14th August 2023

RE: Car Park Assessment 10 Florida Road, Palm Beach

Figure 1 - Proposed Plan (Source Plans prepared by Peter Princi Architects)

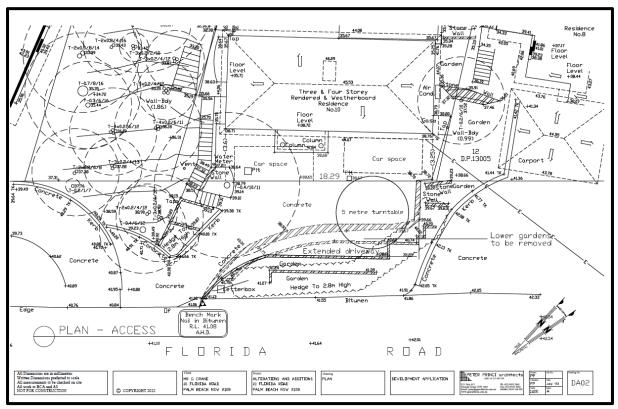
Table 1.1 of AS2890.1 provides a classification of the off-street parking facilities based on various land uses, which is essential in determining the associated parking space dimensions. The proposal involves provision of two car spaces following parallel configuration.

- Space width 2.1 metres
- Space length 5.4 metres (unobstructed)
- Aisle width 3.6 metres

The proposed car spaces were measured to be 2.4m wide, 5.4m long and the aisle width exceeded 3.6m thereby complying with the Australian Standard.

For vehicles exiting the car park, we recommend the area specified in Figure 1 is kept clear of any obstructions.

In relation to the driveway width associated with the Domestic Dwellings Clause 2.6.1 of the AS2890.1-2004 recommends a minimum width of 3.0 metres. The review of the plan indicates the proposed driveway width is in excess to 3.0m and therefore considered compliant.

Figure 2- Minimum Sight Lines for Pedestrian Safety (Source AS2890.1-2204)

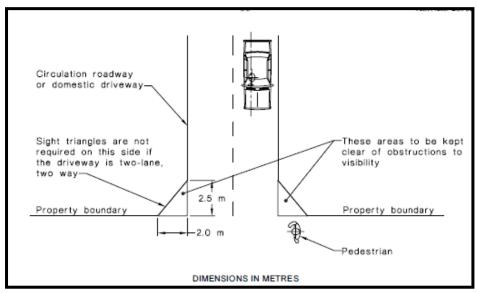
In relation to the pedestrian sight distances Clause 3.2.4 (b) of the Standard stipulates the areas that are required to be kept clear of any obstruction and the figure overleaf indicates this requirement:
